**STATE SIGNIFICANT DEVELOPMENT APPLICATION – 8669
ST ALOYSIUS' COLLEGE – CONCEPT APPROVAL AND STAGE 1 BUILT FORM APPROVAL**

St Aloysius' College – SSDA 8669

Independent Planning Commission

1 North Elevation - Upper Pitt Street
Scale: 1:200

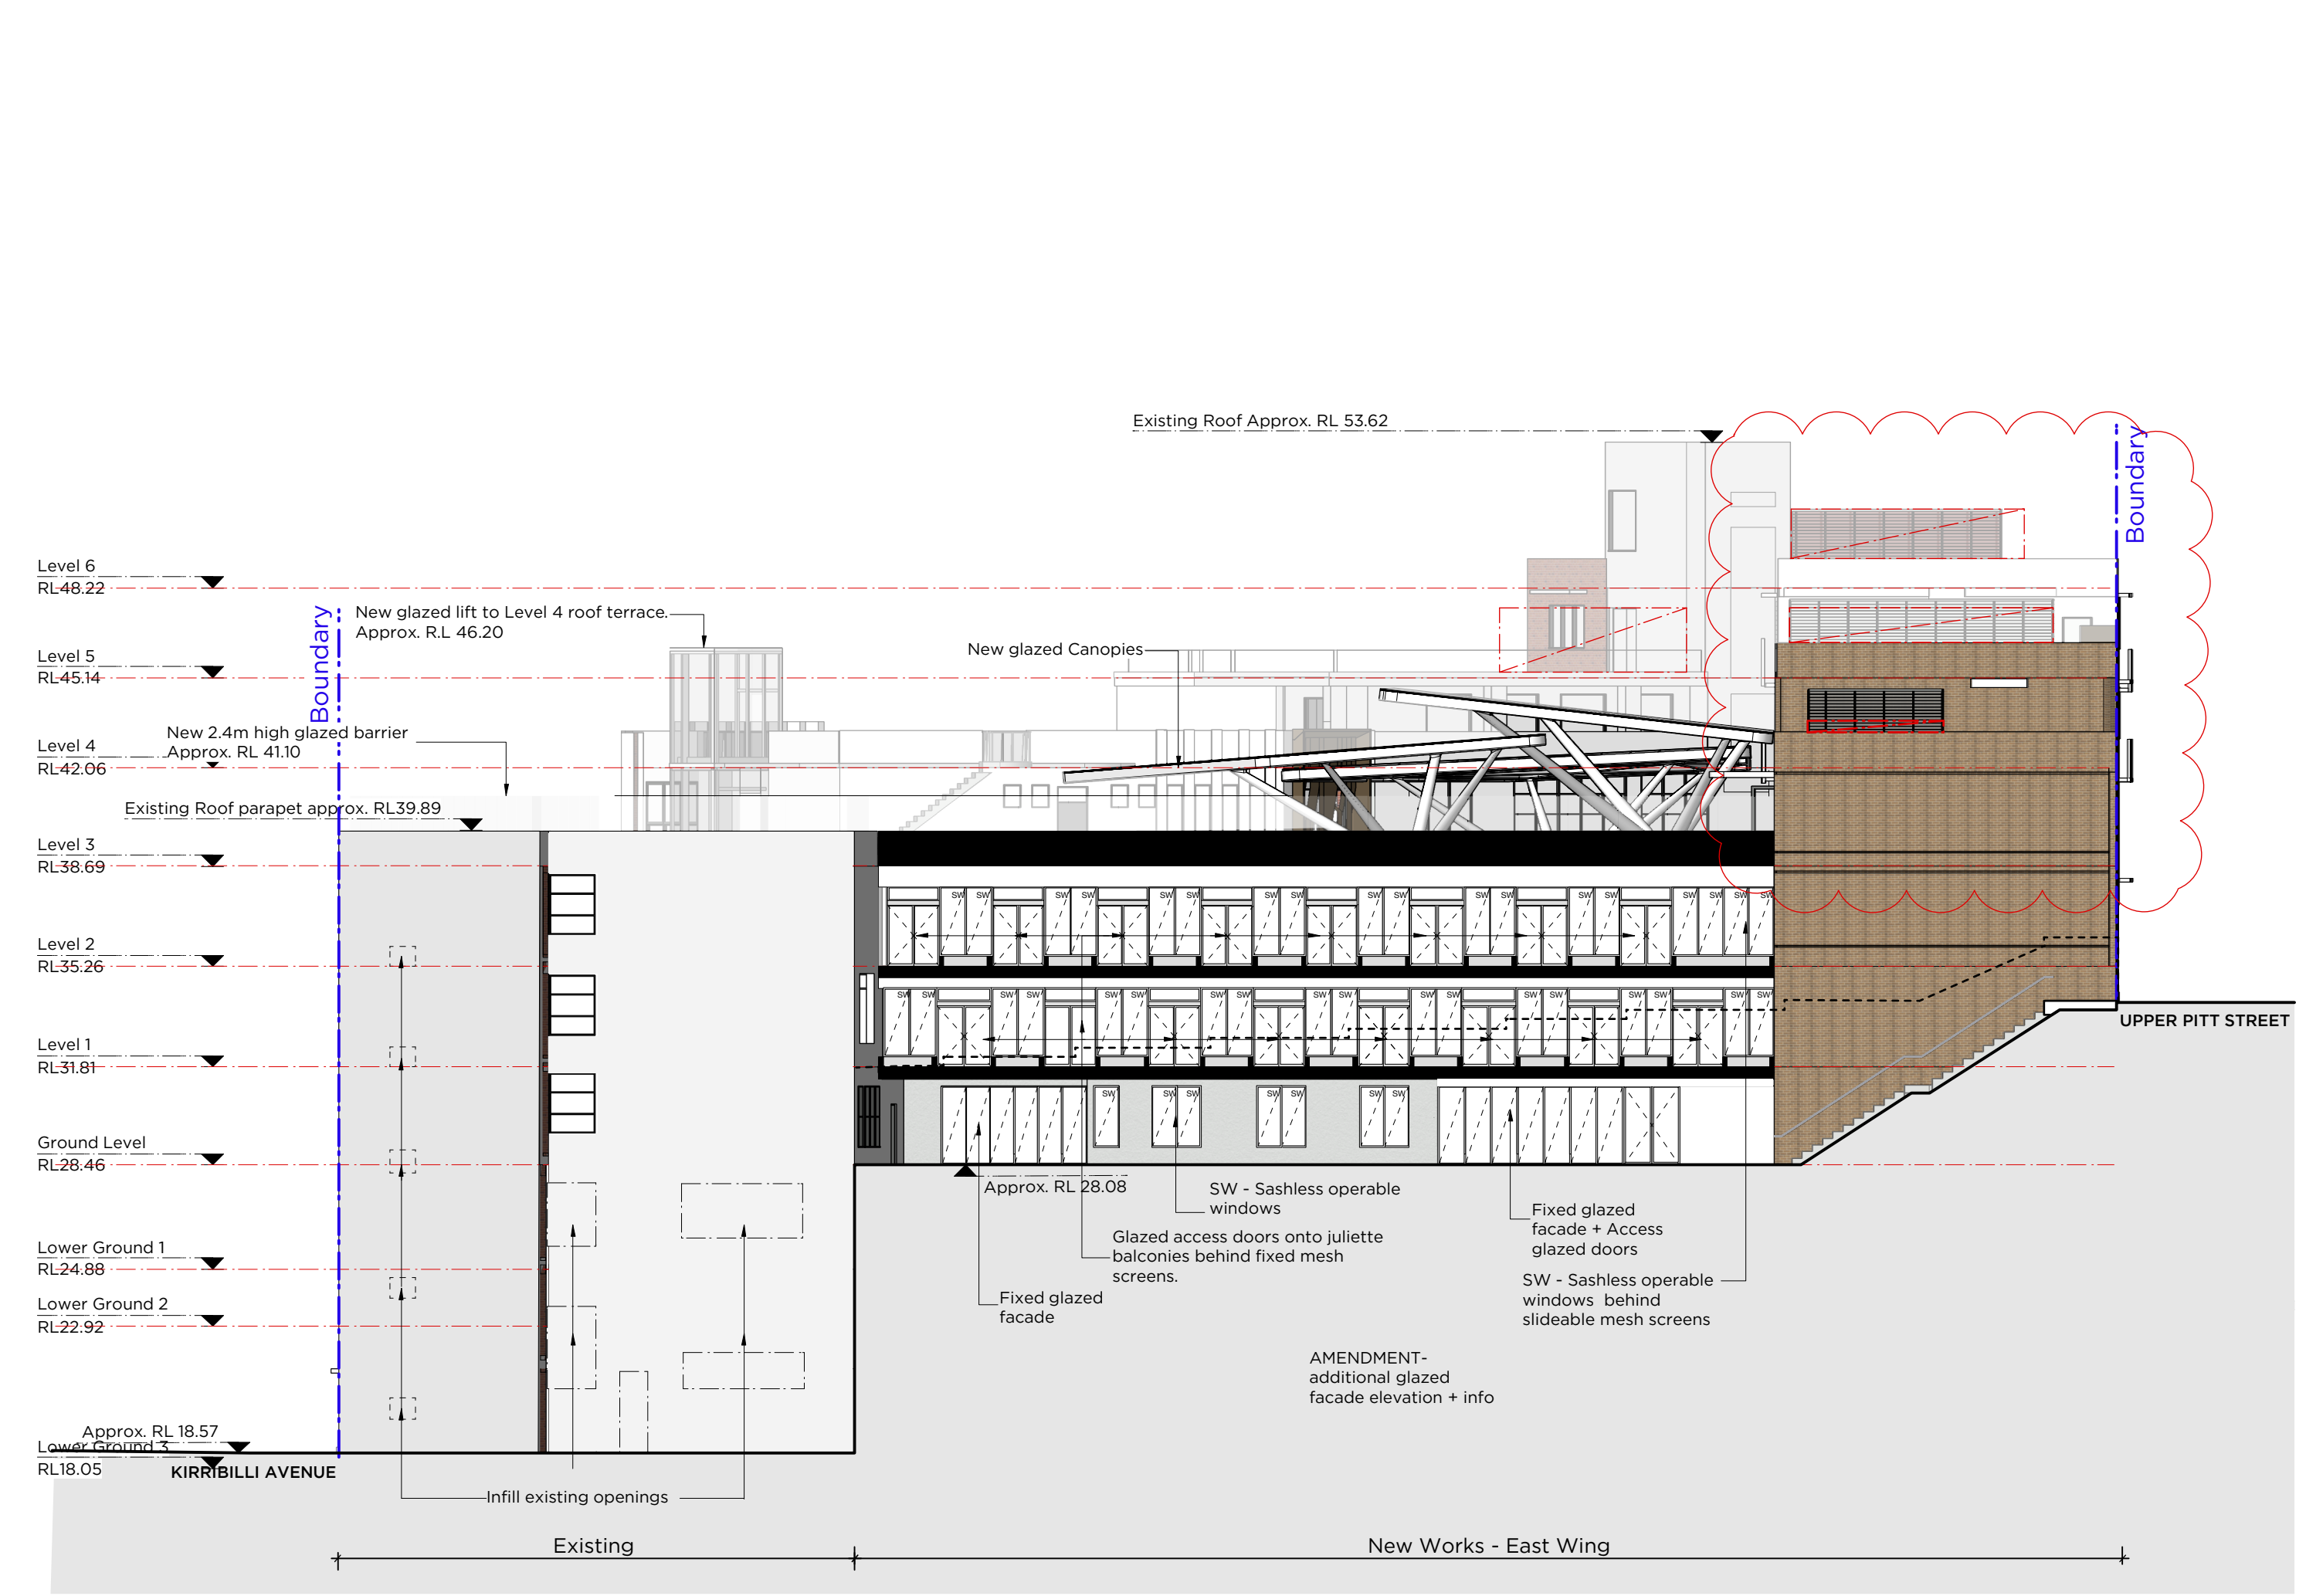
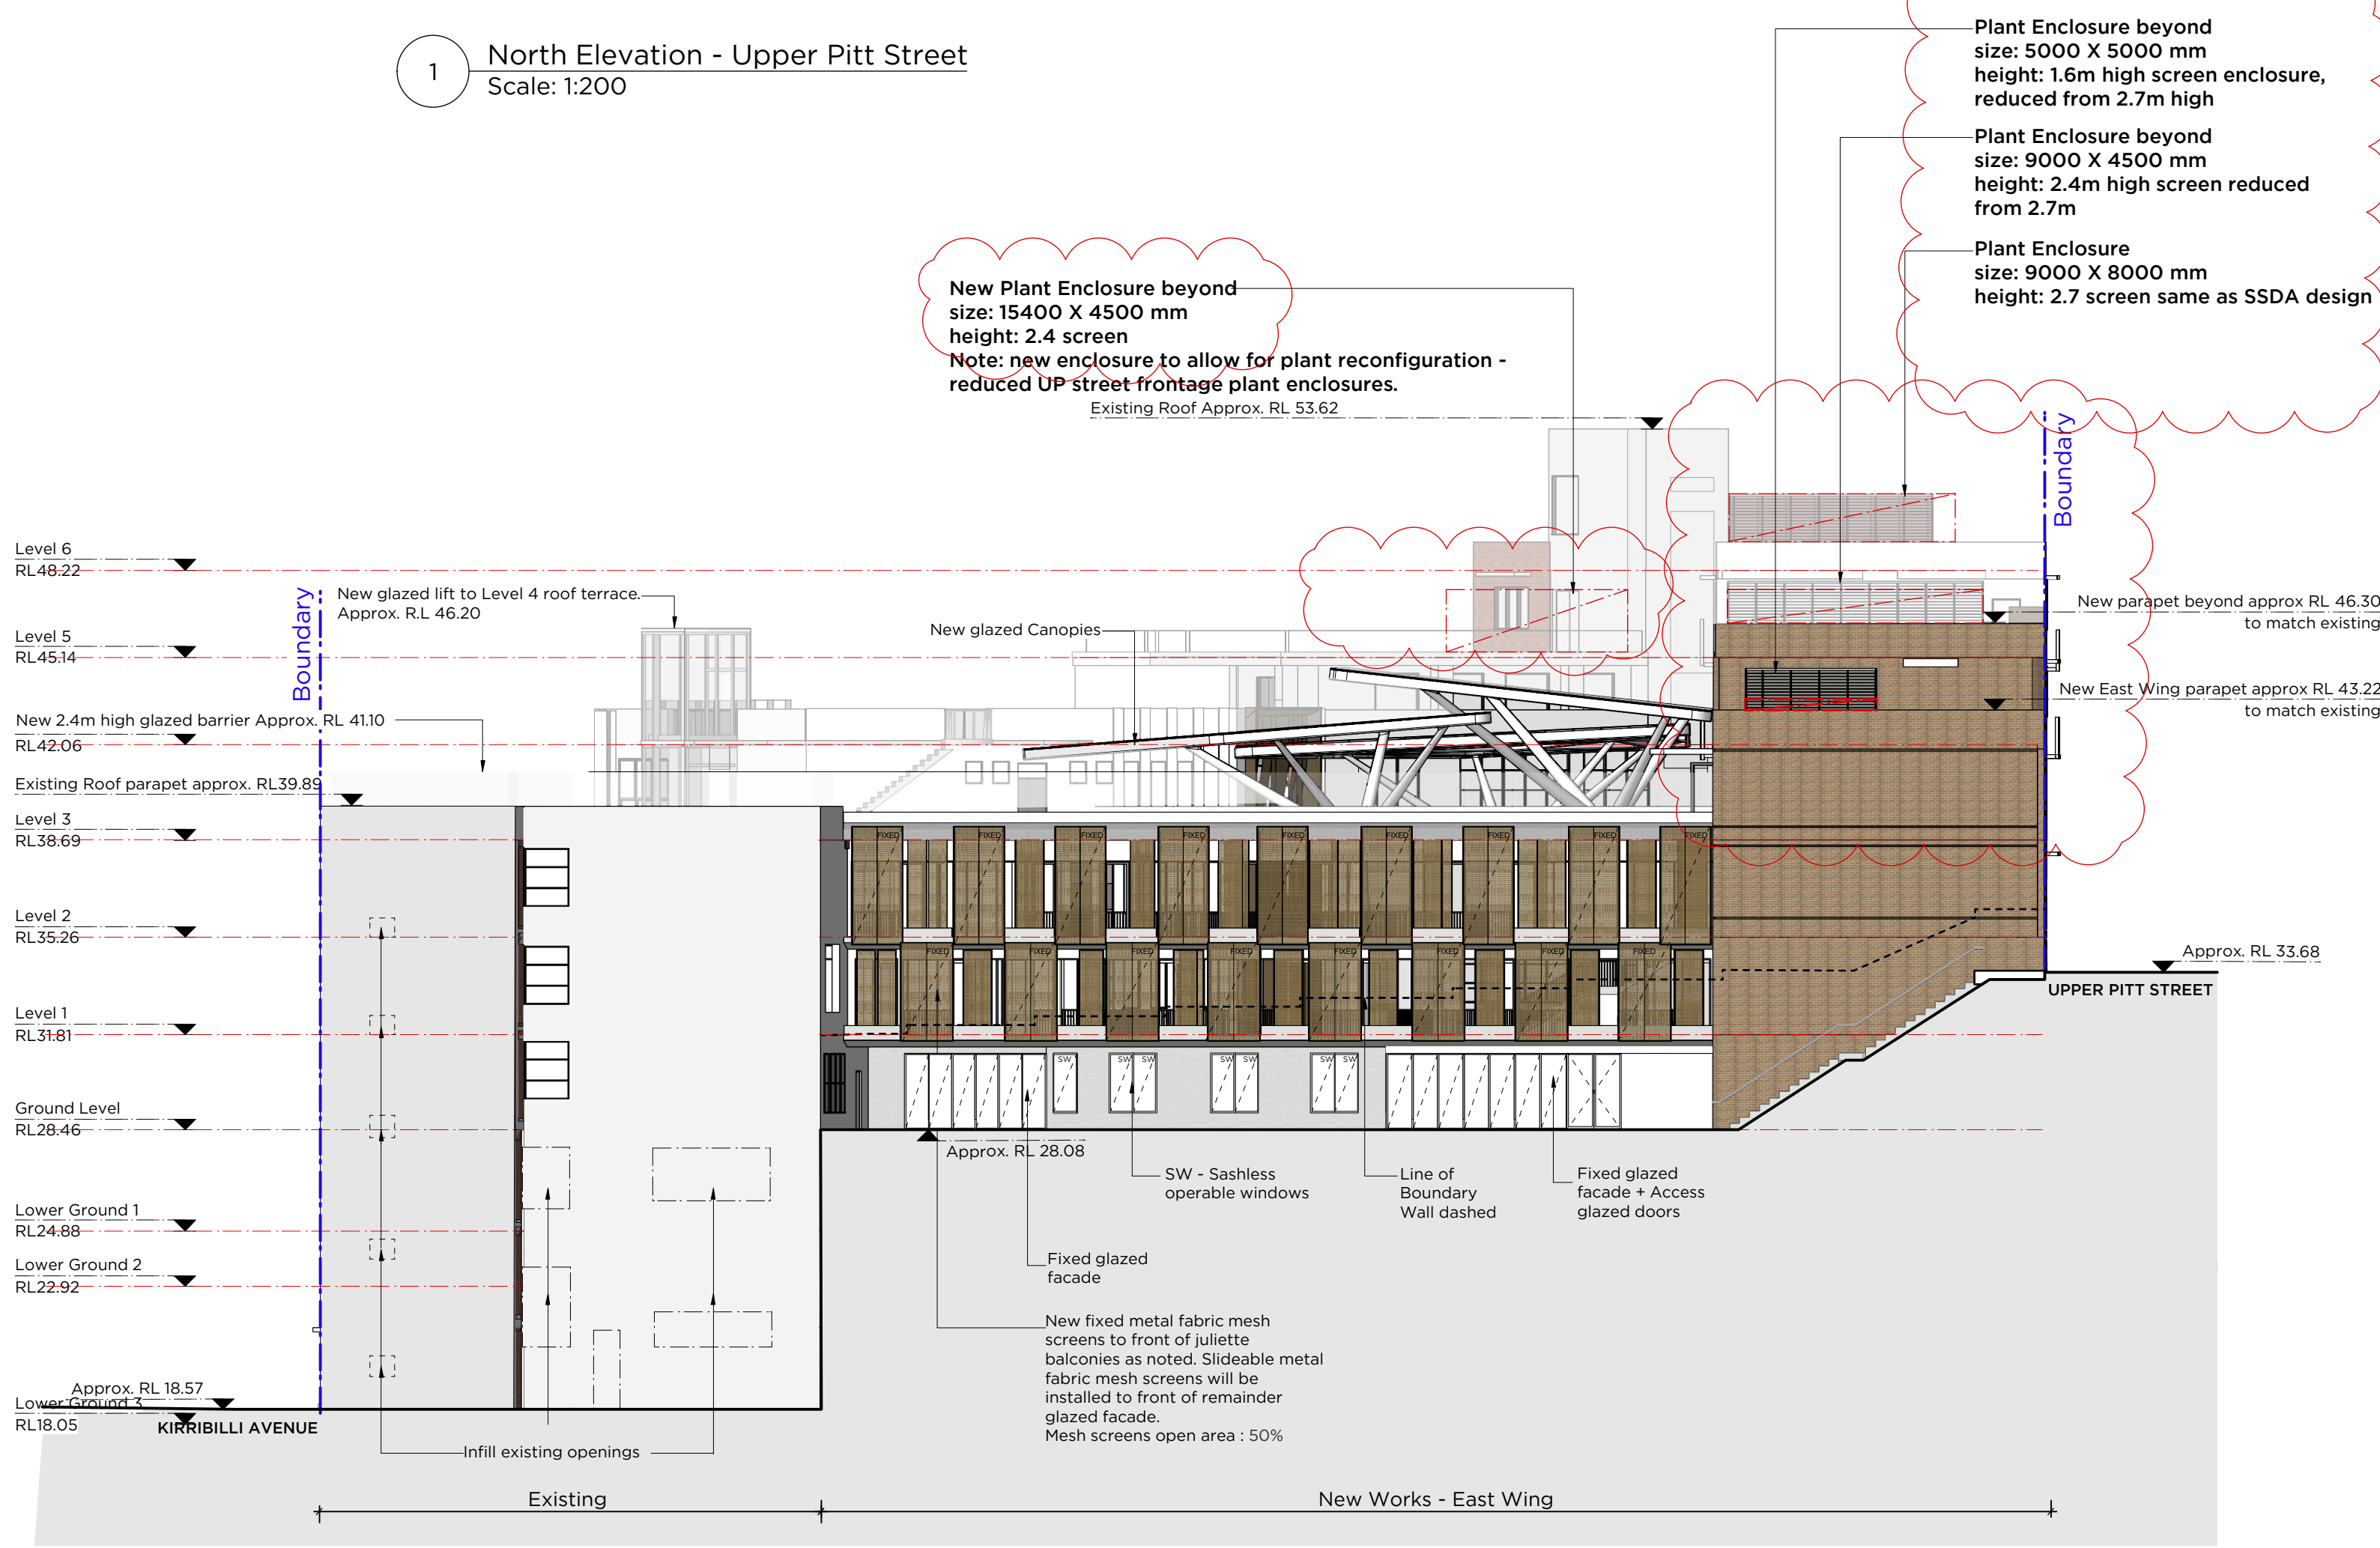
<ul style="list-style-type: none"> Justification for the location of the plant and whether there is any opportunity for relocation or reduction in size. 	<p>Refer to Appendix B, Drawing No. DAU130 and DAU202.</p> <p>The plant room has been amended to improve the views from Upper Pitt Street. Consequently, a new plant enclosure on the Level 5 Roof Level is being sought to accommodate the reduction in plant room on the Upper Pitt Street frontage.</p>
<ul style="list-style-type: none"> Does the plant shown in the southeast building on Levels 1 and 2 service this building as well as the infill building. 	<p>The Plant Room shown on the south-east building on Levels 1 and 2 services the eastern wing and has been adequately addressed in the addendum Noise Impact Assessment prepared by SLR, V3.0, dated April 2019. Figure 10 and extracted below of the addendum Noise Impact Assessment illustrates the location of the mechanical plant for the Main Campus.</p>
